Work Order ID 137643

Item ID: D3394-043 Accept ***N900040100*** Setup Start ***NS1***
 Revision ID: Stop ***NS2***
 Item Name: Lug
 Start Date: 10/19/15 Start Qty: 20.00 ***20*** Cust Item ID:
 Required Date: 10/19/15 Req'd Qty: 20.00 ***20*** Customer:
 Reference:

DRAWING NO. D3394	TITLE LUG	REV. B	DART AEROSPACE LTD ENGINEERING ORDER		D.E.O. NO. D3394-B-1	SHEET NO. SHEET 1 OF 1	SCALE NTS
DRAWN AJS	CHECKED	MFG. APPR.	APPROVED		DE APPR.		
DATE 09.11.04	DATE 09.11.04	DATE 09.11.04	DATE 09.11.04		DATE 09.11.04

DRAWING NO. D3394	TITLE LUG	REV. B	DART AEROSPACE USA, INC ENGINEERING ORDER		D.E.O. NO. D3394-B-2	SHEET NO. SHEET 1 OF 1	SCALE NTS
DRAWN JP	CHECKED SC	MFG. APPR. M	APPROVED JP		DE APPR. JP		
DATE 11.05.02	DATE 11.05.09	DATE 11.05.09	DATE 11.05.08		DATE 11.05.09

SECTION A-A

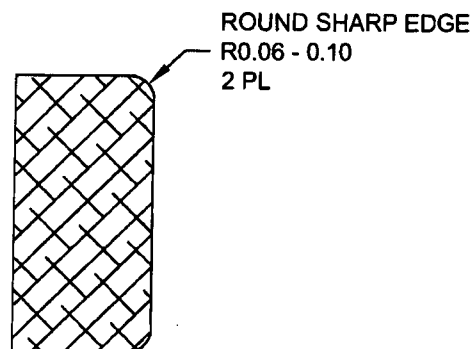
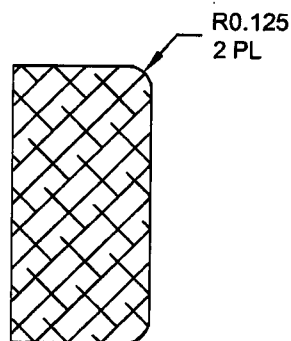
SHEET 4 ZONE A,1 MODIFY SECTION A-A AS SHOWN:

REASON: DRAFTING ERROR

D3394-1RG LUG (SHOWN)
D3394-3RG/-5RG LUGS (SIMILAR)
D3394-041RG/-043RG/-045RG LUG ASSEMBLIES (SIMILAR)

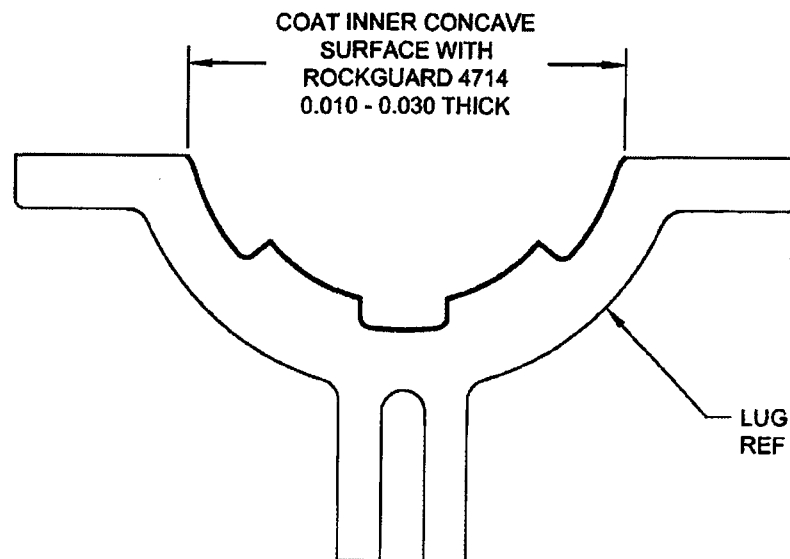
ADD D3394-xRG OPTION

D3394-xRG MOUNTING LUGS ARE INDENTICAL TO D3394-x MOUNTING LUGS, HOWEVER AFTER FINISH, COAT INNER CONCAVE SURFACE WITH "PLUS ONE ROCKGUARD 4714" AS SHOWN BELOW.
